PRODUCT CHANGE NOTIFICATION (PCN)

A-MCSP-80030 MODULAR CABLE

CHANGE NOTIFICATION: PCN 20220425_A-MCSP-80030

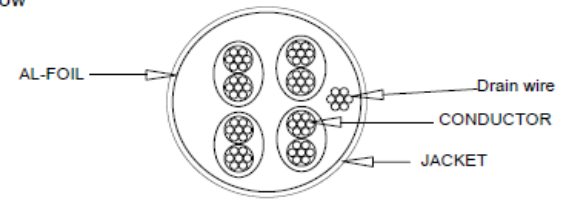
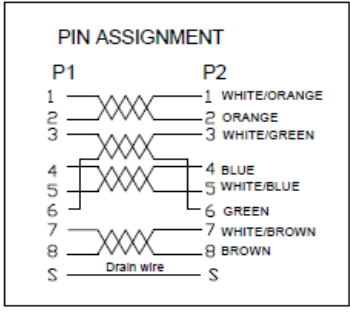
A-MCSP-80030	OLD VERSION	A-MCSP-80030	NEW VERSION																																																						
<p>Appearance</p>		<p>Appearance</p>																																																							
<p>BOM</p> <table border="1"> <thead> <tr> <th></th> <th>NO</th> <th>PART NO</th> <th>DESCRIPTION</th> <th>QTY</th> <th>UNIT</th> </tr> </thead> <tbody> <tr> <td></td> <td>3</td> <td>mold</td> <td>PVC,50P</td> <td>9.0</td> <td>G</td> </tr> <tr> <td></td> <td>2</td> <td>plug</td> <td>8P8C plating gold 3U* with metal shield</td> <td>2</td> <td>PCS</td> </tr> <tr> <td>⑤</td> <td>1</td> <td>cable</td> <td>FTP (26AWG*1P)*4+D+A+PVC, OD:5.2±0.2mm CAT5E</td> <td>2.0</td> <td>M</td> </tr> </tbody> </table>			NO	PART NO	DESCRIPTION	QTY	UNIT		3	mold	PVC,50P	9.0	G		2	plug	8P8C plating gold 3U* with metal shield	2	PCS	⑤	1	cable	FTP (26AWG*1P)*4+D+A+PVC, OD:5.2±0.2mm CAT5E	2.0	M	<p>BOM</p> <table border="1"> <thead> <tr> <th></th> <th>NO</th> <th>PART NO</th> <th>DESCRIPTION</th> <th>QTY</th> <th>UNIT</th> </tr> </thead> <tbody> <tr> <td>⑦</td> <td>①</td> <td>AL-Foil</td> <td>Double-sided conductive aluminum foil</td> <td>2</td> <td>PCS</td> </tr> <tr> <td>⑦</td> <td>②</td> <td>mold</td> <td>PVC,65P</td> <td>AR</td> <td>G</td> </tr> <tr> <td></td> <td>③</td> <td>plug</td> <td>8P8C plating gold 3U* with metal shield</td> <td>2</td> <td>PCS</td> </tr> <tr> <td>⑦⑤</td> <td>④</td> <td>cable</td> <td>CAT5E F/UTP (26AWG*1P)*4+D+A+PVC, OD:5.2±0.2mm</td> <td>AR</td> <td>M</td> </tr> </tbody> </table>			NO	PART NO	DESCRIPTION	QTY	UNIT	⑦	①	AL-Foil	Double-sided conductive aluminum foil	2	PCS	⑦	②	mold	PVC,65P	AR	G		③	plug	8P8C plating gold 3U* with metal shield	2	PCS	⑦⑤	④	cable	CAT5E F/UTP (26AWG*1P)*4+D+A+PVC, OD:5.2±0.2mm	AR	M

NO	PART NO	DESCRIPTION	QTY	UNIT																																																				
	3	mold	PVC,50P	9.0	G																																																				
	2	plug	8P8C plating gold 3U* with metal shield	2	PCS																																																				
⑤	1	cable	FTP (26AWG*1P)*4+D+A+PVC, OD:5.2±0.2mm CAT5E	2.0	M																																																				
	NO	PART NO	DESCRIPTION	QTY	UNIT																																																				
⑦	①	AL-Foil	Double-sided conductive aluminum foil	2	PCS																																																				
⑦	②	mold	PVC,65P	AR	G																																																				
	③	plug	8P8C plating gold 3U* with metal shield	2	PCS																																																				
⑦⑤	④	cable	CAT5E F/UTP (26AWG*1P)*4+D+A+PVC, OD:5.2±0.2mm	AR	M																																																				
FOR DETAIL, PLEASE TAKE ATTACHED NEW DRAWING: FOR REFERENCE

NO	PART NO	DESCRIPTION	QTY	UNIT
⑦	△	AL-Foil Double-sided conductive aluminum foil	2	PCS
⑦	△	mold PVC,65P	AR	G
⑦	△	plug 8P8C plating gold 3U* with metal shield	2	PCS
⑦⑤	△	cable CAT5E F/UTP (26AWG*1P)*4+D+A+PVC, OD:5.2±0.2mm	AR	M
